RE: Notification of Construction Completion on telecommunication facilities

EM/TS #	Address	Town	Sprint ID	Decision Date
EM-SPRINT-104-150421	2 Hinkley Hill Road	Norwich	CT23XC114	05/11/2015

red lines

NETWORK VISION MMBTS LAUNCH

**1 ENLARGED EQUIPMENT LAYOUT PLAN (EXIST)**  
SCALE: 3/8" = 1'-0"

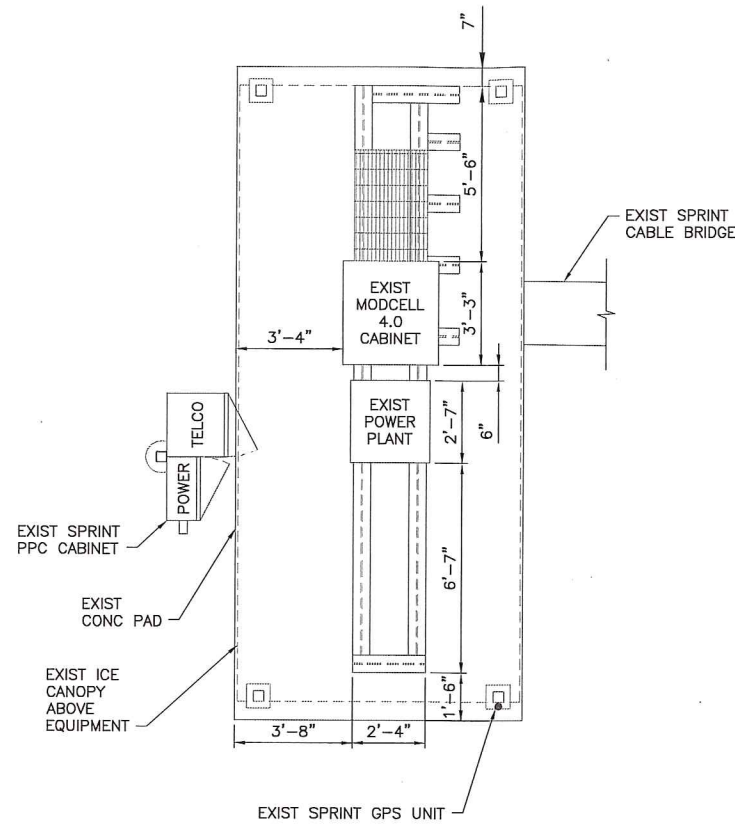
dc/fiber box

1 TYPICAL ELECTRICAL & TELCO PLAN  
E-1 SCALE: NTS

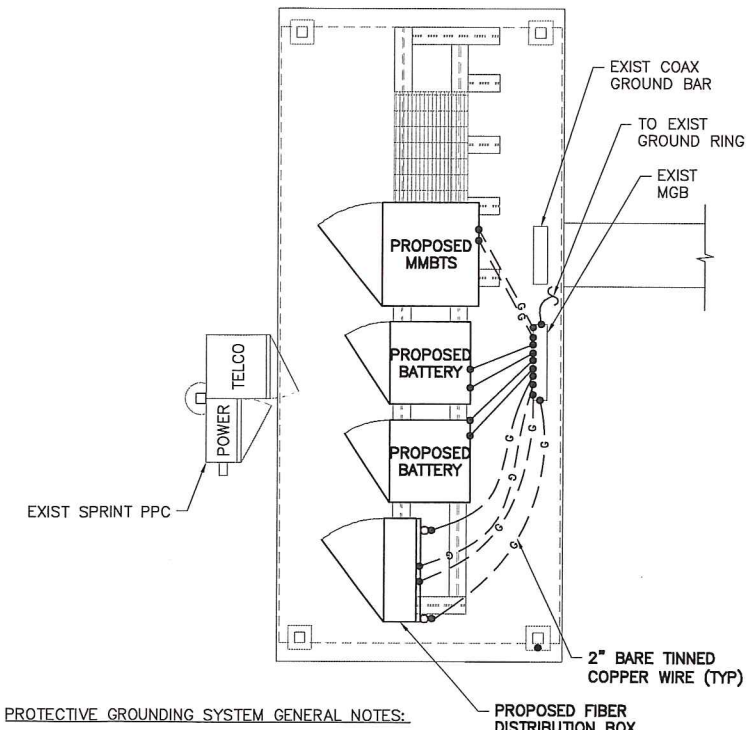
dc/fiber box
